Product Service Bulletin: On the Qt Door Handle Screw Replacement

Orangebox has identified a preventative service need for the door handle of On the Qt (Style # OB1QT01, OB1QT02, OB1QT03, OB1QT04). The screws that secure the door handle could come loose overtime and cause the laminate glass to crack. To correct this issue, all On the Qt phonebooths shipped between March 1, 2021 to March 28, 2022 will require replacement screws with a locking patch for the door handle.

Door Handle Replacement Screws

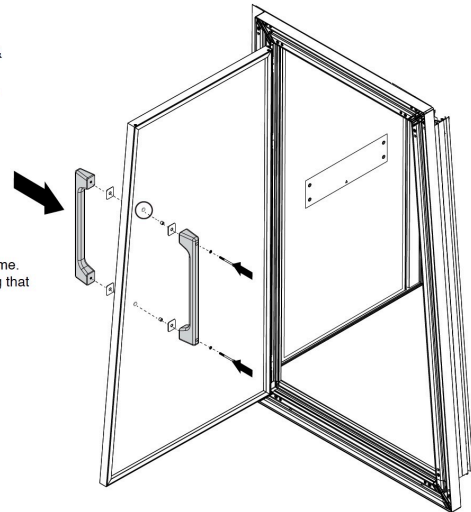
Remove 2x existing cap screws & replace with 2x new screws with pre-applied thread locking patch.

It's best to replace 1 screw at a time. Ensure not to lose plastic bushing that protects the glass
